SERVICE TECHNICAL INFORMATION

ONE POINT REPAIR

REF.NO. : S1-95-015
CUSTOMER RELATION & SERVICE DIV.

- MODELS : LCX-50, LCX-AP1
 SUBJECT : Does not display
 SYMPTOM : In the LCX-50, there are cases in which the display stops functioning. If such symptoms are indicated by the customer, perform the following remedy. (Please disregard Service Technical News G-94-40.)
 REMEDY : Change the chip condenser of the front P.C.B.
 (1) Ref. No. C18 C-CAP 0.033 μ F -> C-CAP 0.022 μ F BK (capacity change)
 (2) Ref. No. C21, 24 CAP M 0.1 μ F -> C-CAP 0.1 μ F (change from mylar to a chip material)

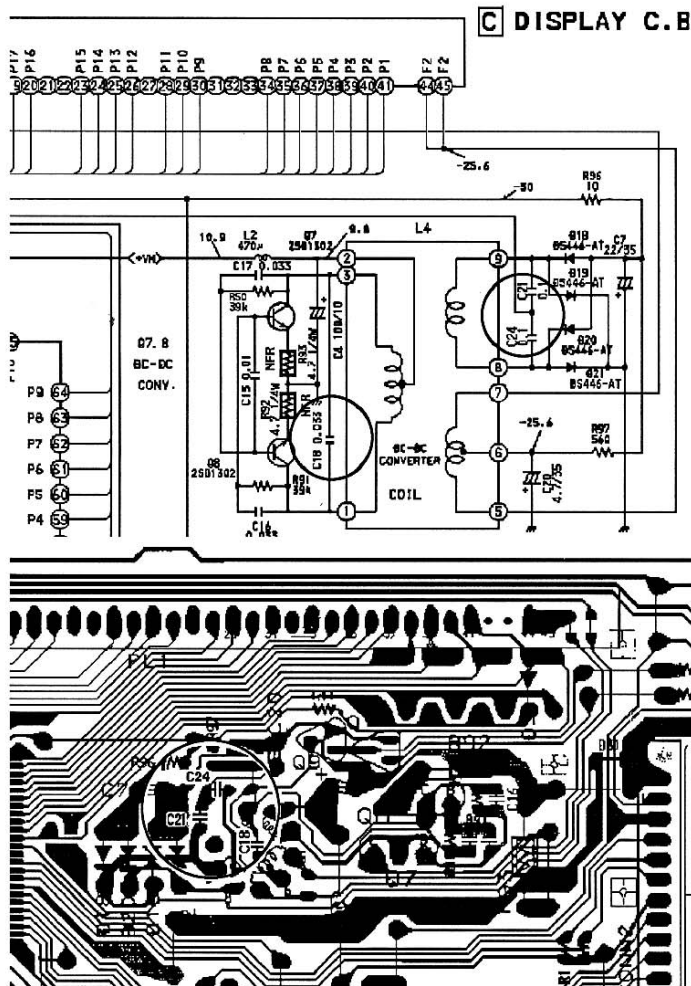
- NOTES
- Applicable production lot: 11/94 ~ 2/95 (Mylar condensers C21 and 24 are soldered on the rear side of the P.C.B.)
 - Perform only remedy (1) for models produced before 11/94.
 - For boards with sever burns around the DC-DC converter, replace the front P.C.B.

Ref.	部品名	部品番号
C18	T-CAP 0.022 μ F	87-010-198-089
C21, 24	T-CAP 0.1 μ F	87-010-196-089
-	DISPLAY CB	SV-T00-012-010
